Access Compliance Report

Public Rights-of-Way

(Curb Ramps)

Intersection ID: N/A	Main Street: W_W_T_HARRIS_BV	Cross Street: NORTHLAKE_PLAZA_DR	Location: SE
ADA ID: 8BDF09869EEE	Ramp Type: Perp	Initial Pass/Fail: Pass	Overall Compliance: No
Codes/Mitigation Info/Possible Solution		Field Measurements/Component Compliance	
Severity Score: 15

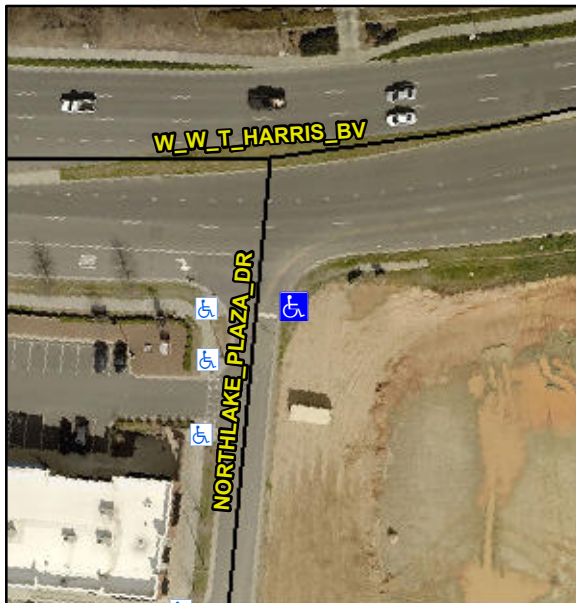
**Not Found, R304.2.1, R304.2.2-Perp,
R304.3.2-Para, R304.5.3, R305.2,
R304.5.4**

Compliance	Description	Data	Compliance	Description	Data
N/A	Ramp Length (in)	96.0	Yes	Ramp Slope (%)	5.3
Yes	Ramp Width (in)	48.0	Yes	Ramp XSlope (%)	0.8
N/A	Flare Type LT	Sloped	N/A	Flare Type RT	N/A
N/A	Flare Slope LT (%)	4.1	N/A	Flare Slope RT (%)	5.7
N/A	Flare Traversable LT?	No	N/A	Flare Traversable RT?	No
No	Landing Length (in)	N/A	Yes	DWS Provided?	Yes
No	Landing Width (in)	N/A	Yes	DWS Contrast?	Yes
No	Landing Slope (%)	N/A	Yes	DWS Length (in)	24.0
No	Landing X Slope (%)	N/A	Yes	DWS Full Width?	Yes
N/A	Landing Curb? (Y/N)	No	No	DWS Offset (in)	3.0
N/A	Shared Landing?	No			
Yes	Gutter Ponding?	No	No	Gutter Slope (%)	7.1
Yes	Gutter Lip Ht (in)	0.0	Yes	Gutter X Slope (%)	0.4
N/A	Painted X Walk1?	No	N/A	Painted X Walk2?	N/A
	X Walk 1 Direction	To W		X Walk 2 Direction	N/A
N/A	X Walk 1 Width (in)	N/A	N/A	X Walk 2 Width (in)	N/A
	X Walk 1 Slope (%)	0.7		X Walk 2 Slope (%)	N/A
	X Walk 1 X Slope (%)	0.5		X Walk 2 X Slope (%)	N/A

N/A	Ramp inside XWalk1?	N/A	N/A	Ramp inside XWalk2?	N/A
	Road Slope (%)	N/A	N/A	Clear Space?	Yes
	Road X Slope (%)	N/A	N/A	Clear Space to XWalk (in)	N/A
Yes	Any Obstructions?	No	Yes	Storm Grate/Utility Hazard?	No
	Obstruction Type			Storm Grate/Utility Type	
		N/A			N/A
			Yes	Surface Condition? (G/P)	Good

**Remove & Replace Entire Ramp.
Remove & Replace Gutter.**
